AMENDMENTS TO THE DRAWINGS:

REMARKS

ANNOTATED REPLACEMENT DRAWING

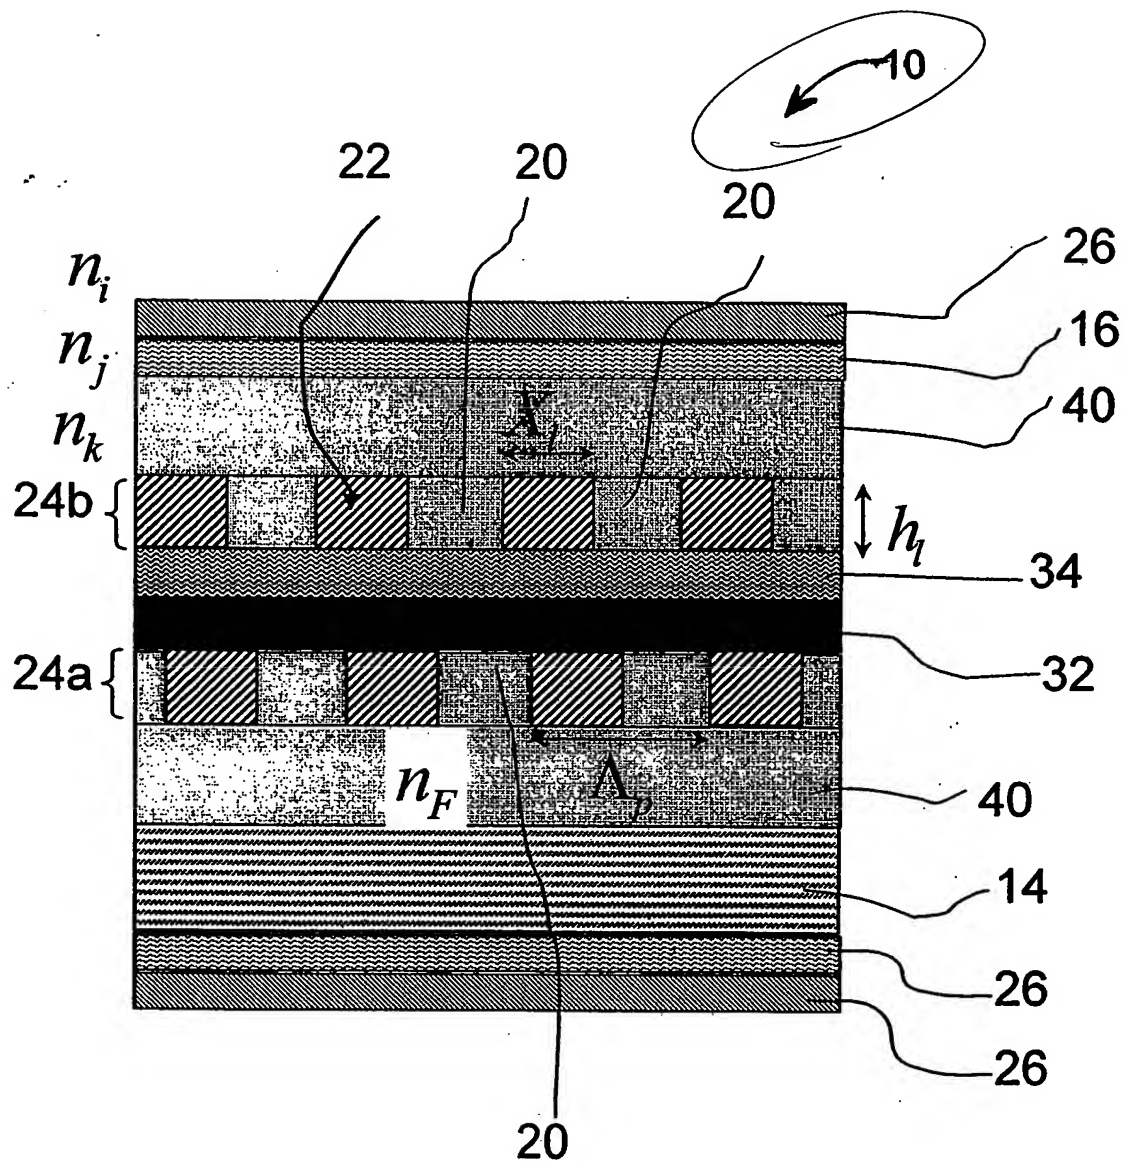
By the foregoing amendment, Applicants are also correcting minor errors to Figures 1 and 2 of the drawings. Revised new drawings of Figures 1 and 2 are attached hereto along with an annotated copy thereof showing the changes.
